LINCOLNSHIRE COUNTY COUNCIL'S RESPONSE TO CONSULTATION ON THE FOLLOWING DEVELOPMENT PROPOSAL

Application number: S24/1040

Proposal: Installation of solar farm with associated battery storage, comprising ground mounted solar photovoltaic panels, including mounting systems, inverters and transformers, electrical substation, underground cabling, stock proof fencing, CCTV, internal access tracks and associated infrastructure for a temporary period of 40 years

Location: Pastures Farm , High Dike, Welby, Lincolnshire, NG32 3LU

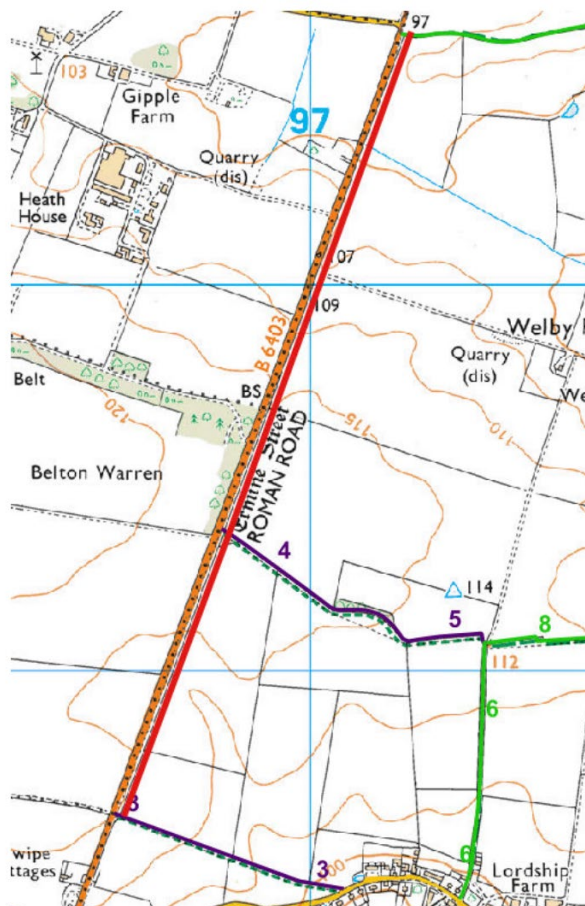
The red line boundary extends in a southerly direction along High Dike. It would therefore be desirable to provide a behind the hedge public footpath or permissive footpath connecting Wilsford BW 13, Welby PF 4 and Welby PF 3 as indicated by the solid red line below.
